Amendment of the Market Ancillary Service Specification (MASS) – Very Fast FCAS

Final Report and Determination

Published: 7 October 2022

Figure 1: AEMO 2022 ISP Storage Projections

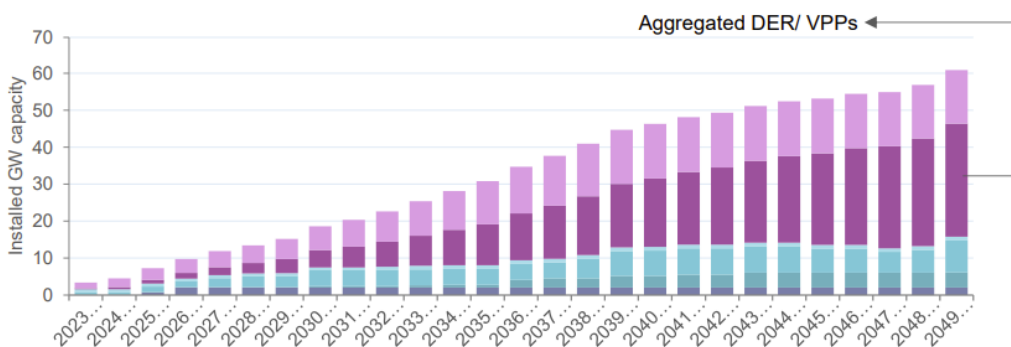
As noted in our previous submission to AEMO, aggregated DER and VPPs are going to make up a significant proportion of the total storage capacity needed across the NEM for the lowest cost energy mix – more than 50% of the installed GW capacity is estimated to be orchestrated DER by 2050²⁶ (see following figure).

It will be critically important that AEMO creates the right market settings to continue to incentivise more controllable DER in the market, and that the costs of market participation do not outweigh the benefits. Where this is the case, we will continue to see passive DER make up the market share.

Figure 1 Power and frequency traces (L), and various methods for assessing frequency response (R)

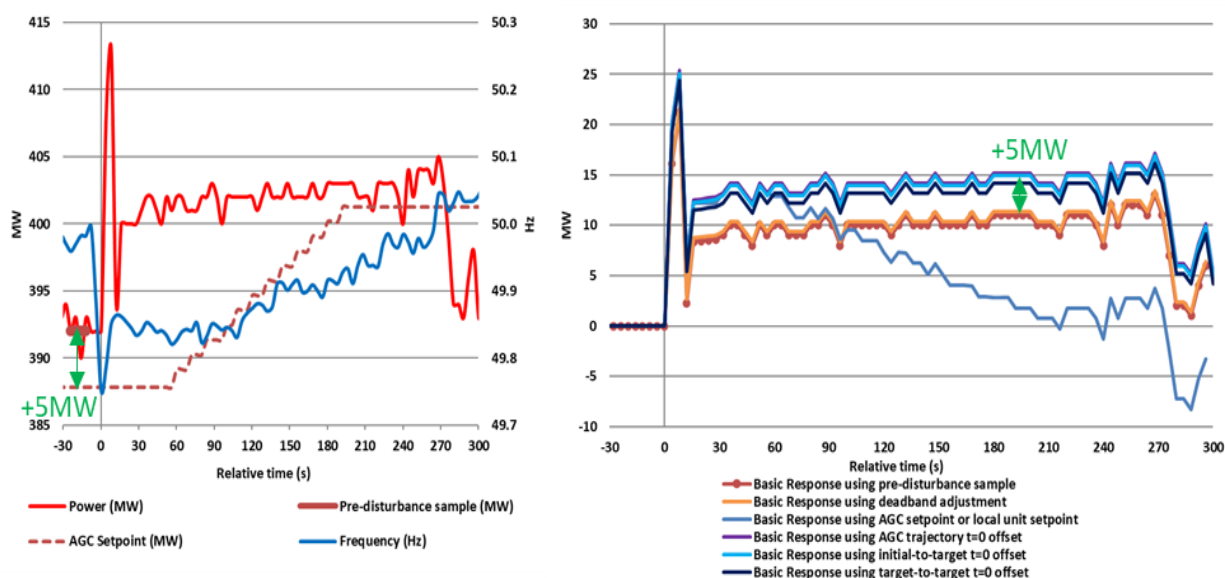
Example outcomes of using the existing ‘pre-disturbance sample’ method and each of the alternative methods to determine the Reference Trajectory are depicted in Figure 1. In this example, which features a relatively long frequency disturbance, and a ramping AGC target, there is a quite a range of outcomes produced by the different calculations.

- It is clear to AEMO that alternative methods need to be considered further, and this could be done with the aid of the ASTAG or other suitable industry collaboration mechanism.
- At this point in time, AEMO is not contemplating a replacement for the existing ‘pre-disturbance’ method, but rather allowing the option of working with FCAS Providers to agree a more representative Reference Trajectory for a given facility.
- AEMO noted that the exact equations for establishing the Reference Trajectory are covered by the MASS FCAS Verification Tool and User Guide, rather than the MASS, and that these can be updated independently of the current formal consultation.

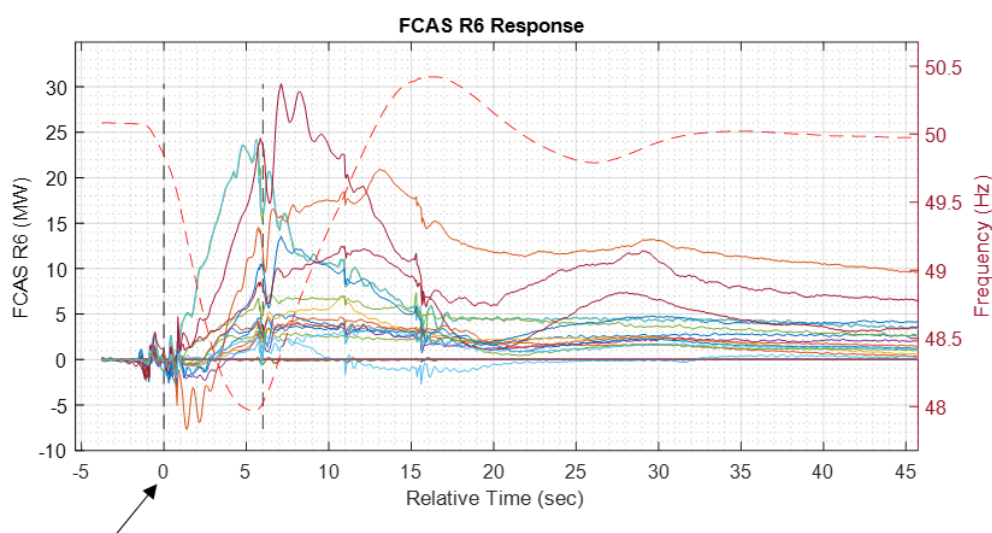
To best illustrate the hydro machine Very Fast FCAS response capability, Hydro Tasmania has reviewed our unit responses to a significant actual system frequency event. Based on 50ms high speed data recorded, the hydro machine governor responses are illustrated in the following plot. Note, the dashed red line represents the system frequency, the other lines represent the hydro machine MW responses at the time.
